Response to the Reviewers' Comments

The authors would like to thank the reviewers for the precious comments and suggestions on the technical contents and presentation of our manuscript "Runtime Power Management of Battery Electric Vehicles for Extended Range with Consideration of Driving Time," submitted to IEEE Transactions on Very Large Scale Integration (TVLSI.) This revised manuscript has been greatly improved thanks to the reviewers' invaluable advices. We have revised the manuscript faithfully following the reviewers's comments. We include the newly added or significantly modified parts in the revised version of the paper also in Response to Reviewers. We highlight the important technical content changes and set those parts in a red color in the revised paper.

Fig. 2: (a) Range-speed experimental data for Chevrolet Bolt [36] and (b) comparison with simulation results of the proposed EV power model.

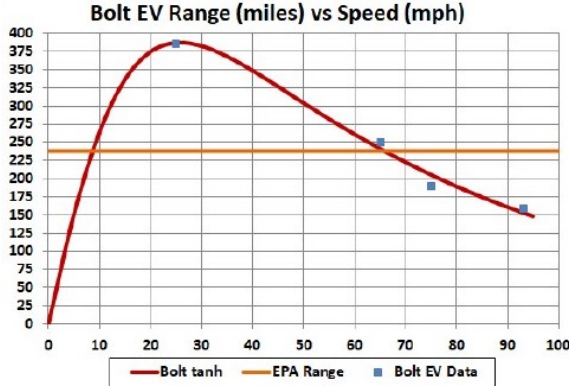
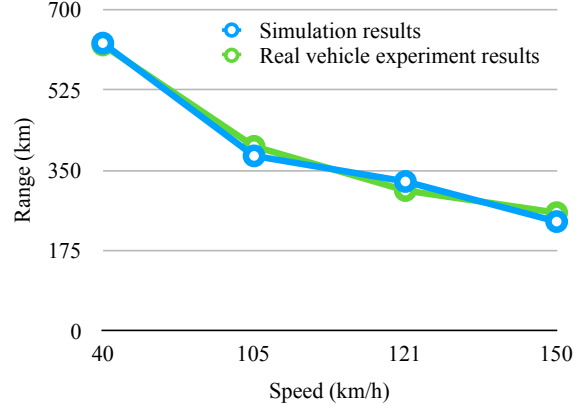
R1-C2 It is not clear how to validate the power model of EV. As the author mentions that accuracy of power model is quite important, it is good to see the power model in this paper can be validated by some real measurement results.

Here goes how we extracted correct coefficients of the EV power equation. We use a vehicle simulator that supports EV as well, ADVISOR, to extract the coefficients of new vehicles starting from known vehicle specifications such as the aerodynamic resistance, rolling resistance, curb weight, and so on. Such data is often published in the users' manual, website and so forth. We further use the vehicle performance data such as the top speed, maximum acceleration, and so on, which are also available on the manuals and website. We iteratively run ADVISOR and derive the model coefficients so that all the known values match among each other. We evaluate the model accuracy with the range-speed real vehicle experiments as shown in Fig. 1(a), which has been published by [32], [33], [34], [35], [36]. We further refine the coefficients until all the available data values match well. Finally, the derived EV power model well matches with the range-speed experimental data as shown in Fig. 1(b) as well as the top speed and maximum acceleration, setting the aerodynamic resistance, rolling resistance, curb weight, etc. with the known (fact) values. The errors of the range-speed simulation is merely 1.4%, the time to approach 60 mph at departure is 7.8%, and the top speed is 3.0%, respectively. We revised the manuscript adding the following paragraph with a new figure in Section III.A on page 3 and 4.

We further evaluate the model accuracy with the range-speed real vehicle experiments as shown in Fig. 2(a) to confirm the derived power models are close enough to the real vehicle measurement data [32], [33], [34], [35], [36]. We refine the coefficients until all the available data values match well.

As a result, the derived EV power model well matches with the range-speed experimental data as shown in Fig. 2(b) as well as the top speed and maximum acceleration setting the aerodynamic resistance, rolling resistance, curb weight, etc. with the known values. The errors in the range-speed simulation is merely 1.4%, the time for 0-to-100 km/h error is 7.8%, and the top speed error is 3.0%, respectively.

Fig. 12: Velocity profile comparison with EDP , E^2DP and E^3DP on Serrano Avenue in Anaheim Hills.

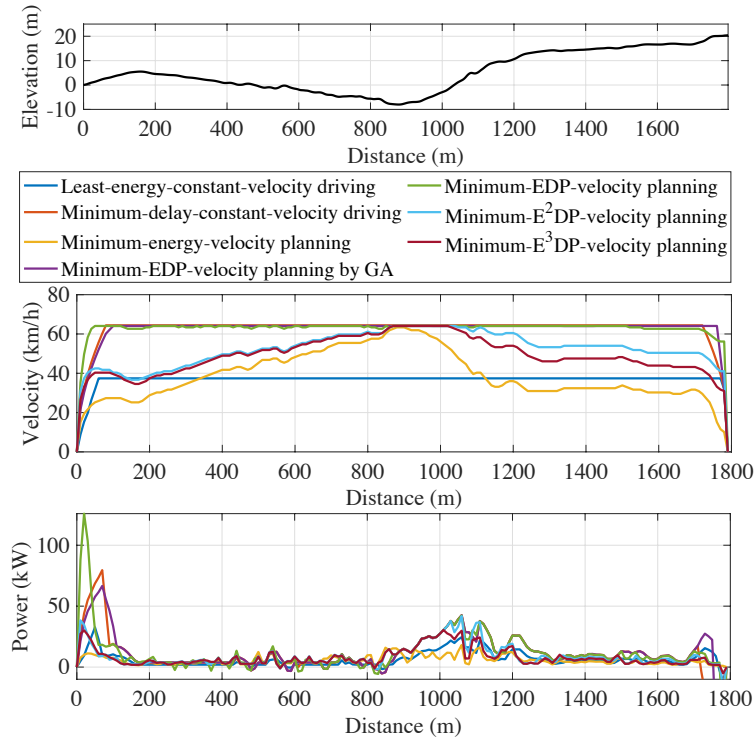
R1-C3 The optimality of the proposed scheduling algorithm is unclear. The author should add several paragraphs to discuss this topic. It is also to see the comparison baseline is well accepted to show the advantage of the proposed algorithm.

Fig. 12 summarizes EDP of the least-energy-constant-velocity driving, the minimum-delay-constant-velocity driving, the minimum-energy-velocity planning, the velocity planning with EDP , E^2DP and E^3DP as a metric on the road benchmarks and the minimum- EDP -velocity planning with GA. The proposed velocity planning results in up to 46.2% improvements of EDP compared with the least-energy-constant-velocity driving. The driving velocity on a flat road is faster than that of the least-energy-constant-velocity driving at the expense of relatively little energy to save driving time. Then, the velocity decreases when climbing the following uphill to spend less motor torque, which saves more energy.

We also updated Fig. 12 and Fig. 13:

Fig. 11: Histograms of velocity and acceleration for the proposed energy-aware-velocity planning methods without an acceleration constraint (a) and (b) and with an acceleration constraint (c) and (d), respectively.

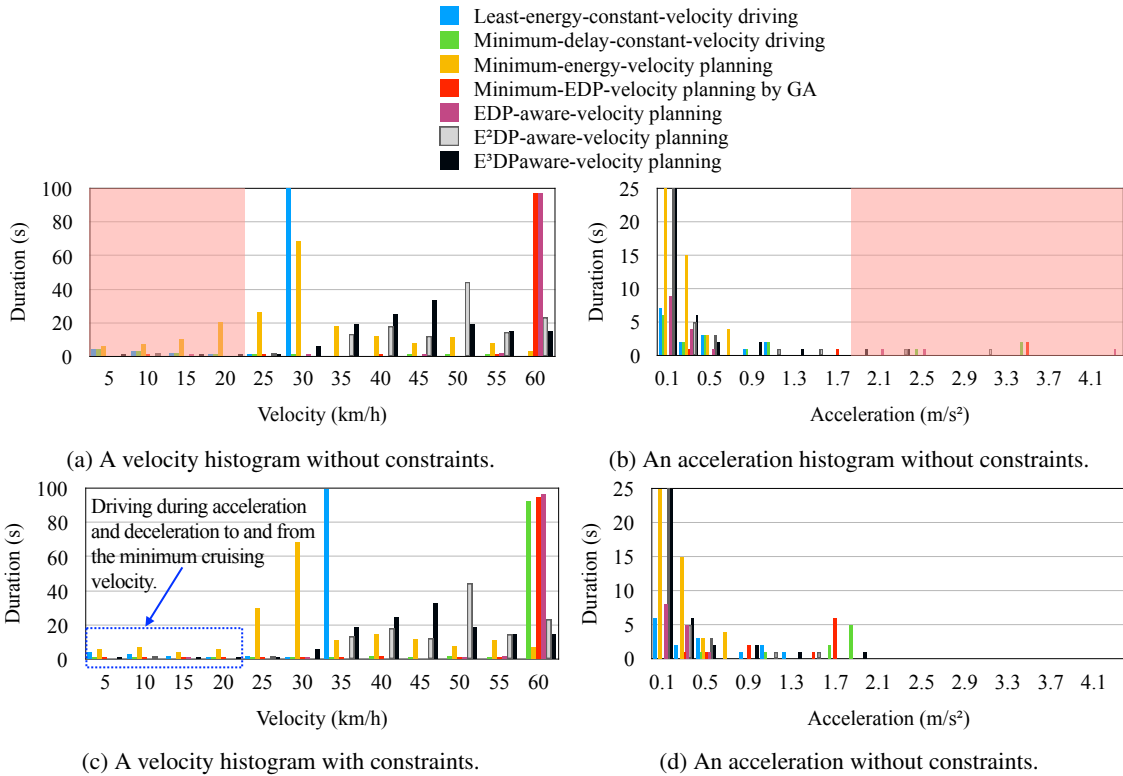
R2-C2 It would be good to have more discussion on the assumptions of the approach and the experiments, e.g., how much can the velocity be changed in practical scenarios without impeding traffic and causing unsafe situations (also depending on the road conditions and whether it is urban or rural environment I suppose). Currently, there only seems to be one constraint on not slower than 10 km/h.

Fig. 11(a) and (b) show two histograms of the driving schemes in Fig. 12, which do not have velocity and acceleration constraints. We avoid a cruising velocity lower than 25 km/h and an acceleration higher than 2.0 m/s^2 in this paper without loss of generality. The acceleration of 2.0 m/s^2 is the same as the maximum acceleration of compact cars designed to be used primarily used in urban areas (13 seconds of 0-to-100 km/h time).

Fig. 11(c) and (d) shows the velocity and acceleration histograms with the constraints. Once we run the DP for the first time without constraints, we analyze the histogram, adaptively determine the minimum cruising velocity and maximum acceleration constraints, and run DP again. We keep the same constraints for online recomputation whenever unexpected interrupts occurs.

We quantize the velocity and acceleration values and make a histogram to analyze population of velocity and acceleration for the proposed energy-aware-velocity planning methods. Fig. 11(a) and (b) show two histograms of the driving schemes in Fig. 12, which do not have velocity and acceleration constraints. We avoid a cruising velocity lower than 25 km/h and an acceleration higher than 2.0 m/s^2 in this paper without loss of generality. The acceleration of 2.0 m/s^2 is the same as the maximum acceleration of compact cars designed to be used primarily used in urban areas (13 seconds of 0 to 100 km/h time).

Fig. 11(c) and (d) shows the velocity and acceleration histograms with the constraints. Once we run the DP for the first time without constraints, we analyze the histogram, adaptively determine the minimum cruising velocity and maximum acceleration constraints, and run DP again. We keep the same constraints for online recomputation whenever unexpected interrupts occurs.

Fig. 8: Altitude changes in the real road benchmarks.

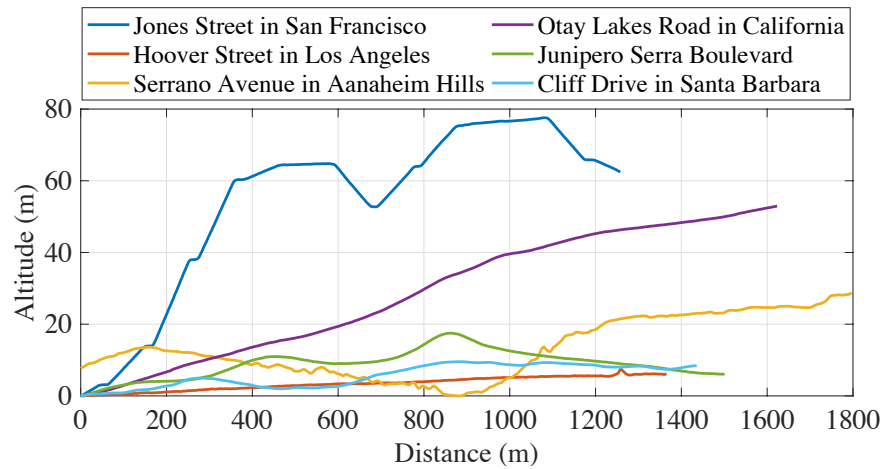
R2-C3 Related to the last point, it would be good to have more discussion on the road benchmarks, e.g., how they are generated and how representative they are. The optimization results significantly depend on road slope. It would be good to use a variety of real road segments for testing.

R2-A3 We appreciate the reviewer's comment. We replaced the previous synthetic road benchmarks with the real road benchmarks. We made six new real road benchmarks from various locations in California. The first three roads are in cities. Jones Street in San Francisco and Hoover Street in Los Angeles are two representative city landscapes such as hills and flat roads, respectively, and Cliff Drive in Santa Barbara is a mixture of those. The second two roads are in mountain areas: Serrano Avenue in Anaheim Hills and Otay Lakes Road in San Ysidro

Mountain in California. The last road is Junipero Serra Boulevard connecting San Francisco and San Jose. The details of road data is summarized in Table II, and Fig. 8, which visualize the altitudes of the road benchmarks. We also revised all the associated contents with the new real road benchmarks.

We choose six roads from various locations in California and make real road benchmarks. The first three roads are in cities. Jones Street in San Francisco and Hoover Street in Los Angeles are two representative city landscapes such as hills and flat roads, respectively, and Cliff Drive in Santa Barbara is a mixture of those. The second two roads are in mountain areas: Serrano Avenue in Anaheim Hills and Otay Lakes Road in San Ysidro Mountain in California. The last road is Junipero Serra Boulevard connecting San Francisco and San Jose. The details of road data is summarized in Table II, and Fig. 8, which visualize the altitudes of the road benchmarks.
